Haul Road and Footpath Mitigation Strategy

Planning Application 11/02499/FULL

Woodland Environmental
October 2011

Cherry Lodge Golf Club
Jail Ln
Biggin Hill,
Westerham
Kent
TN16 3AX

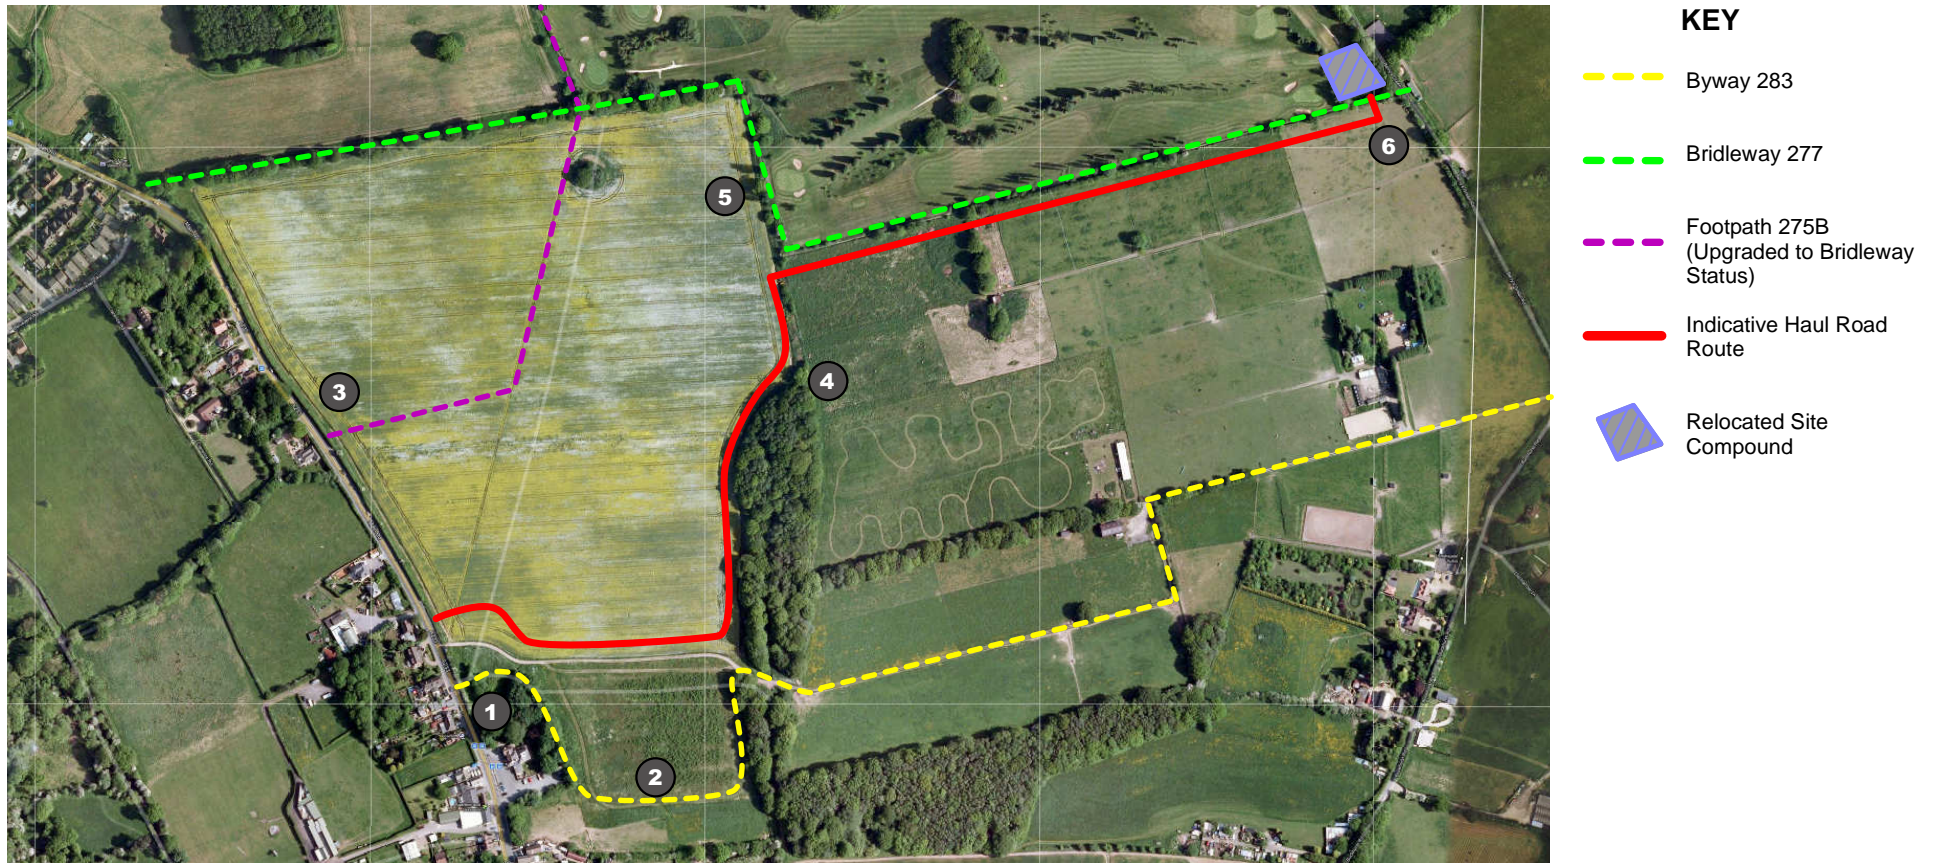
4.0 KEY ISSUES

4.1 In formulating the revised alterations to the haul road and site compound, we have been mindful of the following key issues:

- 1. Ensure all registered Rights of Way remain open and unfettered, with alternative routes made available to public**
- 2. Explore possibility of removing compound from field and reducing in size**
- 3. Address conflict at site entrance between 275B and BY283**
- 4. Avoid HGVs crossing the Byway for access to the wheel washing facility**
- 5. Reduce crossings of BR277 into site**

6.0 PROPOSED AMENDMENTS - Site Compound

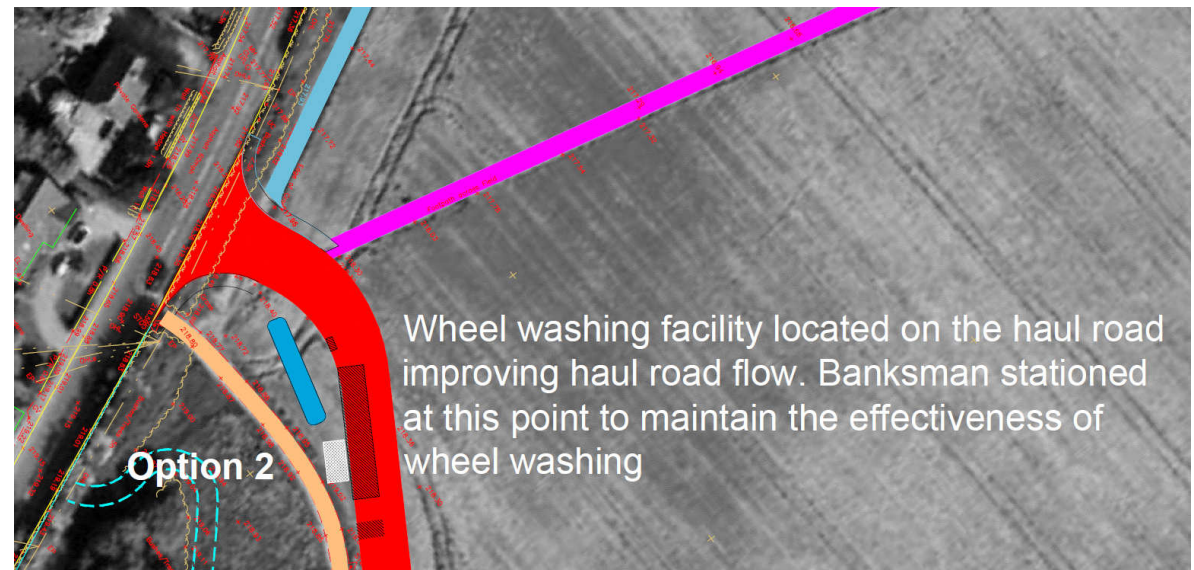
- 6.1 Following comments from objectors to the scheme, it was evident that the site compound formed a main body of contention.
- 6.2 In order to address these comments we have undertaken studies that have shown that the compound can be substantially reduced in size from its former footprint by 5500sqm to just 30sqm in area.

- 6.3 It should be noted that the operation proposed at Cherry Lodge will require far less plant and specialised equipment than normally required in respect of residential or office development, as the majority of works will comprise moving earth with a tracked bulldozer, 360 excavator and dumper truck with no actual cranes, scaffolding, cementing, brickwork or other normally encountered plant required. All machinery for the actual construction works will be stationed on the course itself.

- 6.4 The compound at its minimum specification as shown on the revised plans requires a toilet, site office, parking spaces and area for plant and machinery storage. It is noted that in the British Horse Societies objection to the scheme it is stated that loud machinery would scare horses; however, in the majority of circumstances, no plant of such nature will actually be operated in the site compound.
